North Westerly - PD 2nd Review

To: John Prestwich, PCS Group
From: Aly Burkhalter, Senior Planner
Date: August 16, 2024
Re: PD-001700-2024 North Westerly - PD

2nd Review & Referral Comments

UNDERMINING/ OIL & GAS PLAN

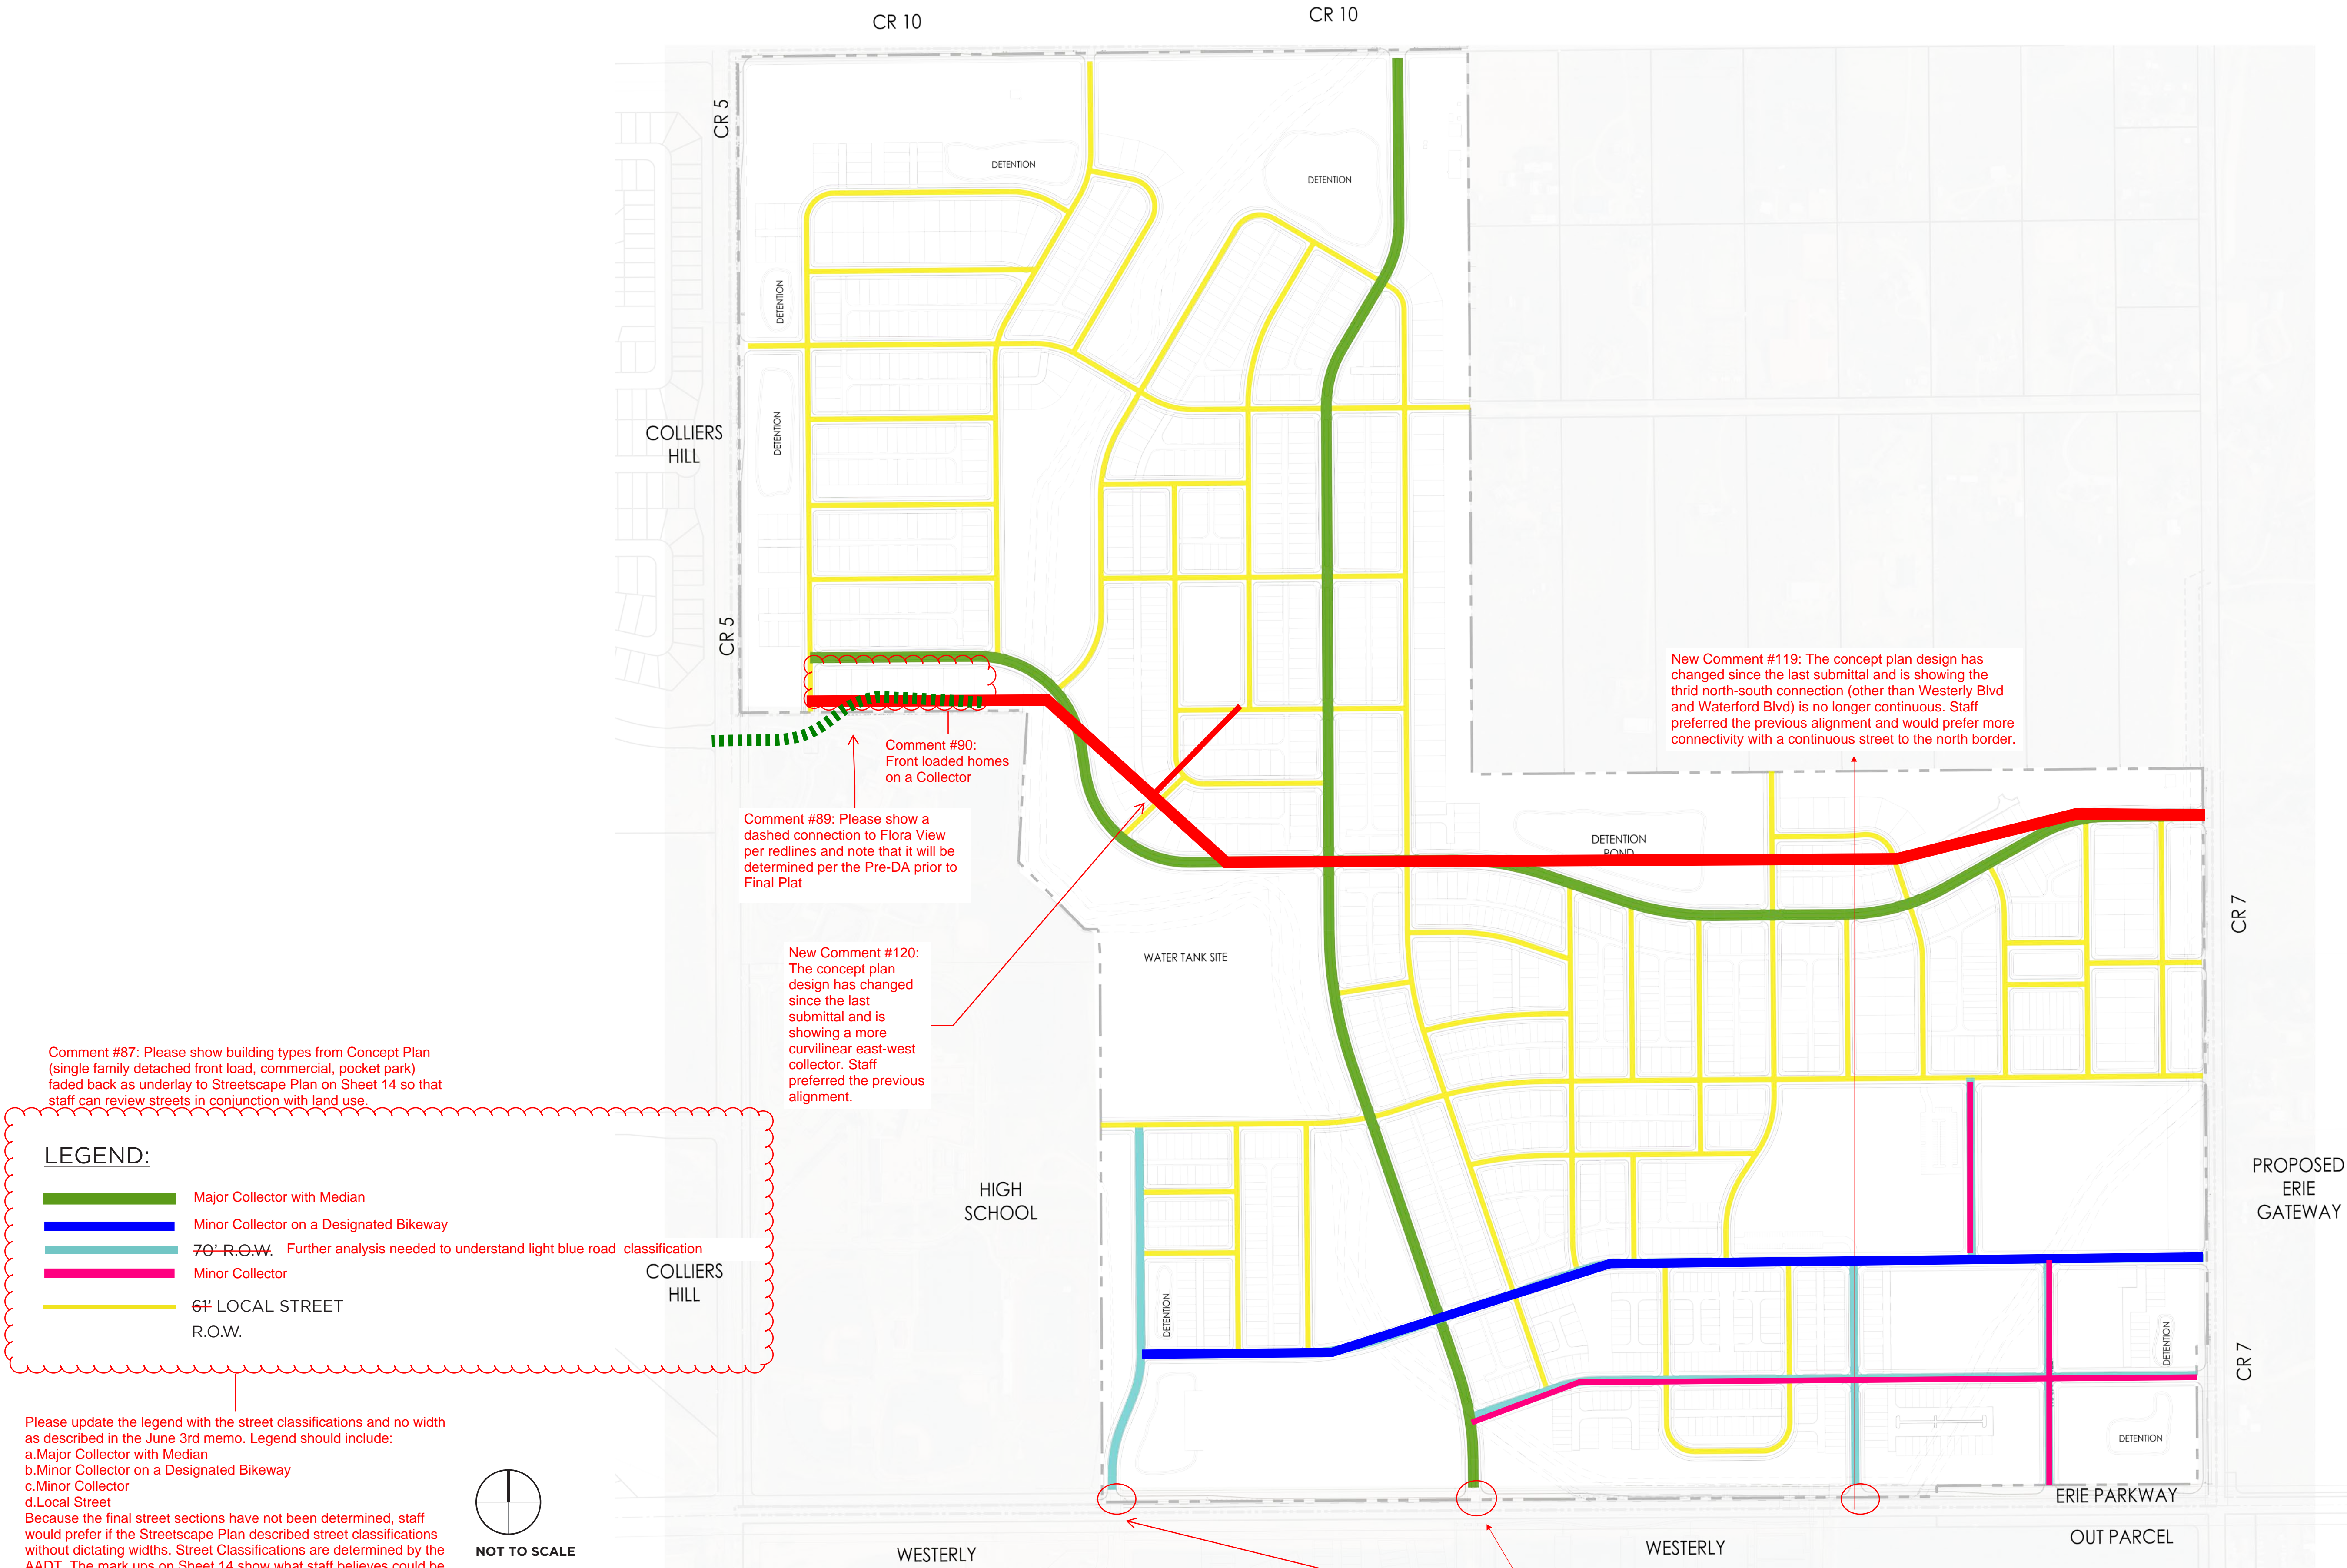
9f Undermining Plan (Sheet 13) – see CGS comments. Please follow the direction provided by Colorado Geologic Survey regarding geotechnical considerations and mine subsidence as these present potentially significant impacts which could alter development

111. It is indicated in the Mine Subsidence Report that buildings should be limited to less than 165-ft and two-stories or less in the Subsidence Zone A. It is unclear where this area is indicated on Undermining Plan (Sheet 13 of the PD Zone Map and Guide). Additionally no structures should be located within 25-ft of the capped shafts of the Clayton Mine which was not clearly demarcated on the Undermining Plan. Applicant RESPONSE: An updated subsidence report has been included with this submittal. Town Response: Resolved. Please see comments #68 and #69 above.

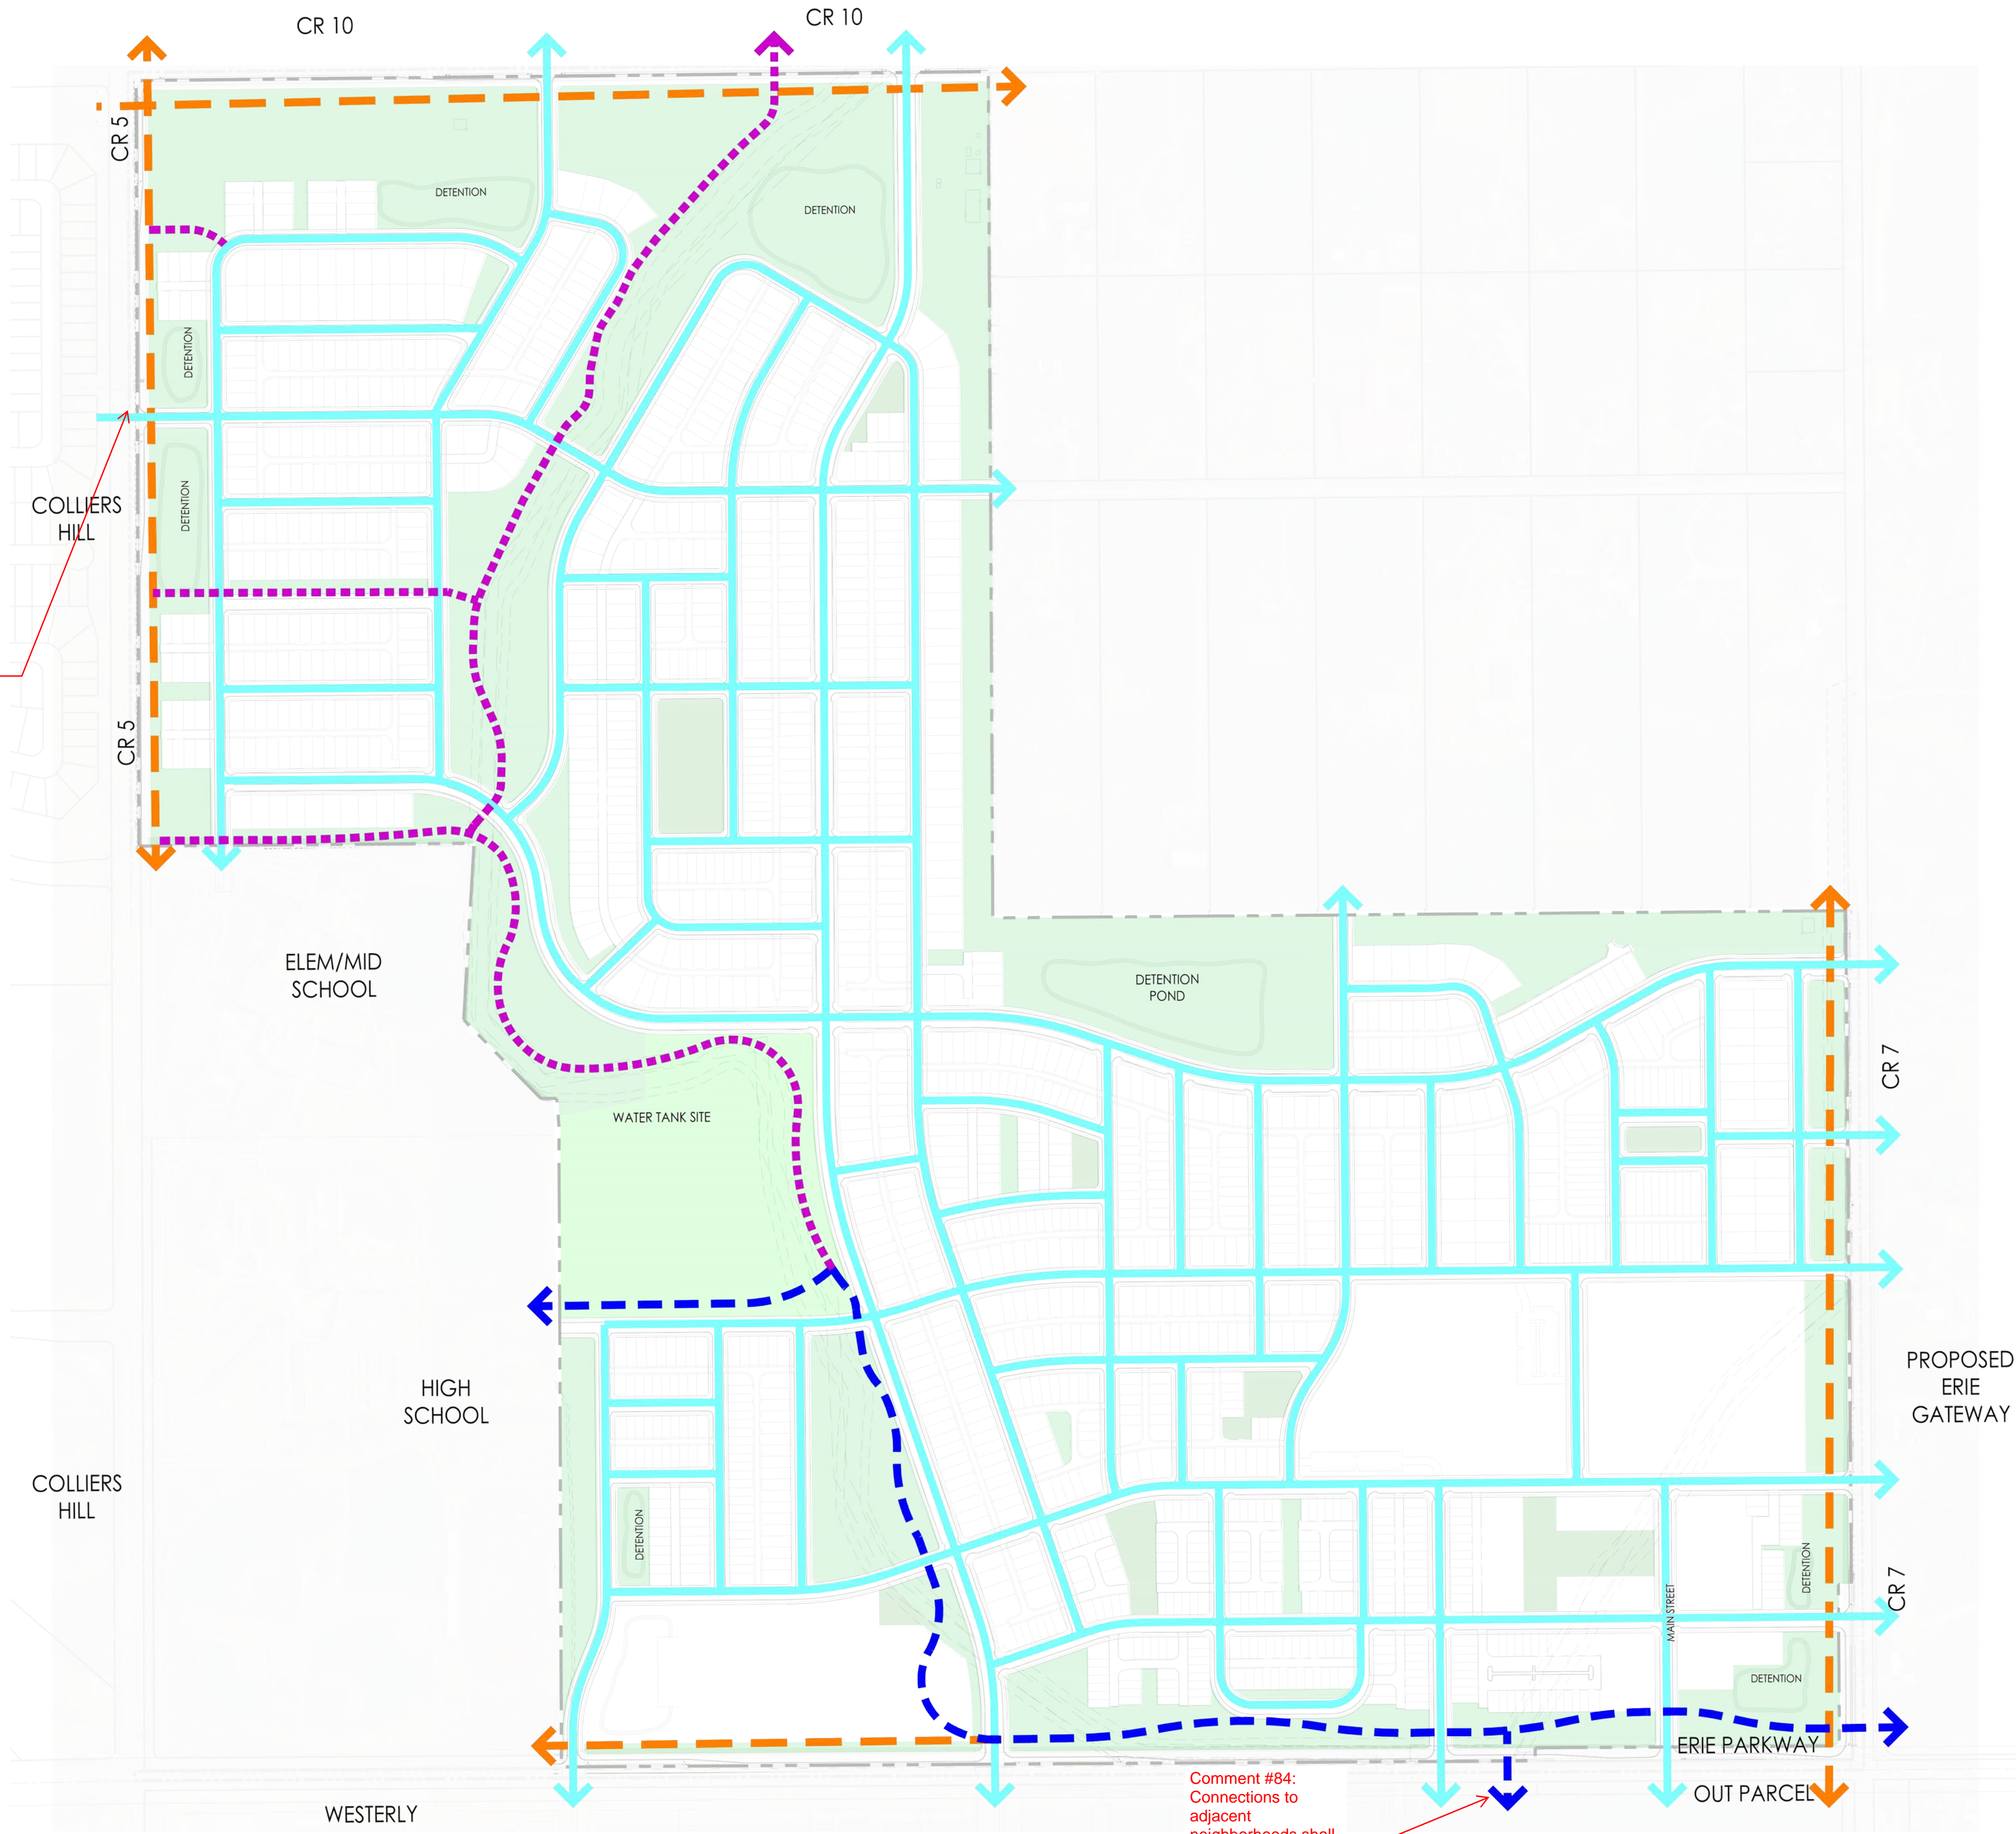
Comment #84: Connections to adjacent neighborhoods shall be labeled and noted as at-grade crosswalk, overpass, or underpass

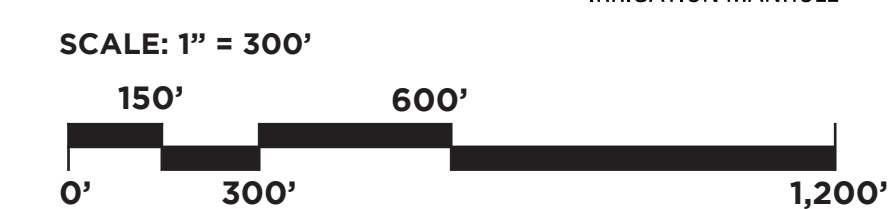
#21. Label this connection

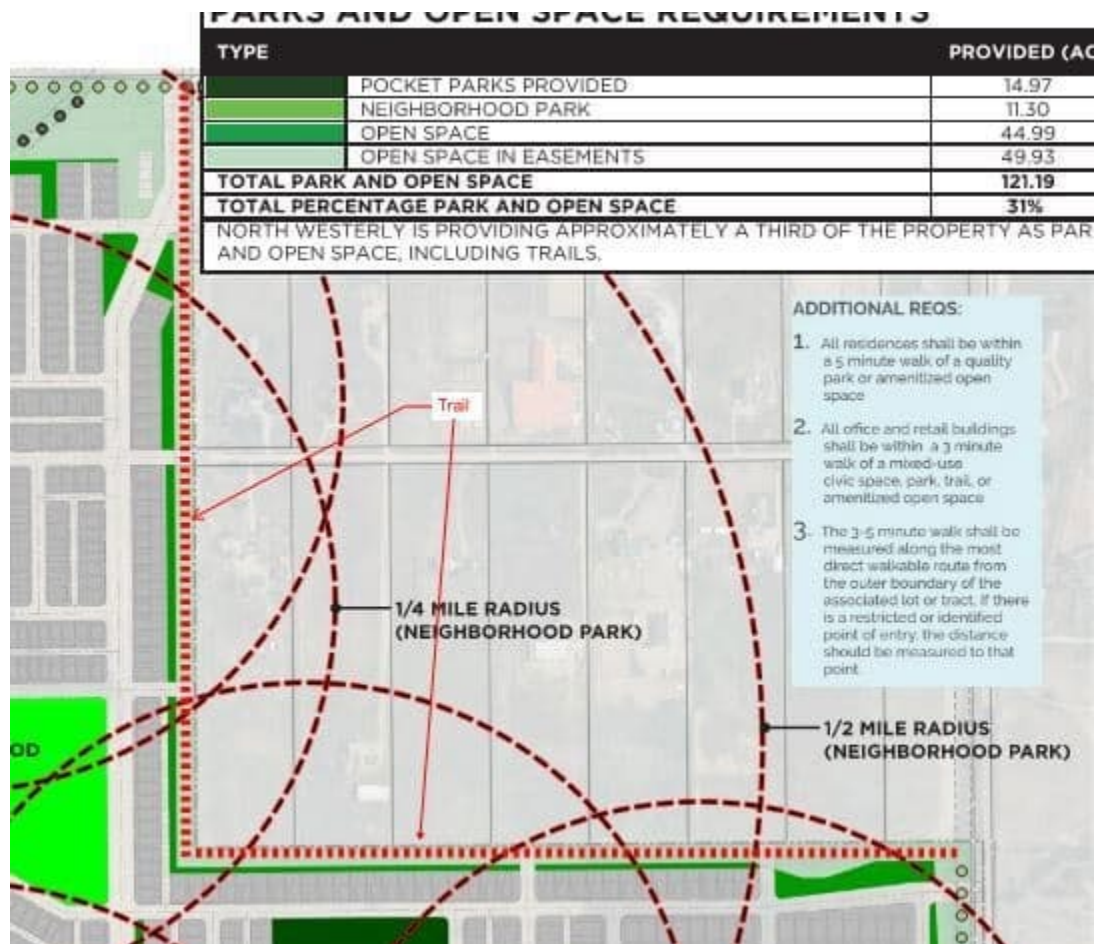
Response: It is acknowledged that we not longer are required a ¼ mile radius. However, the mixed-use development guide emphasizes a 3-5 min. walk from open space and parks; the ¼ mile radius is the best way to show this. But we can remove them if the Town feels it is necessary.

TOE: OK to leave the radii.
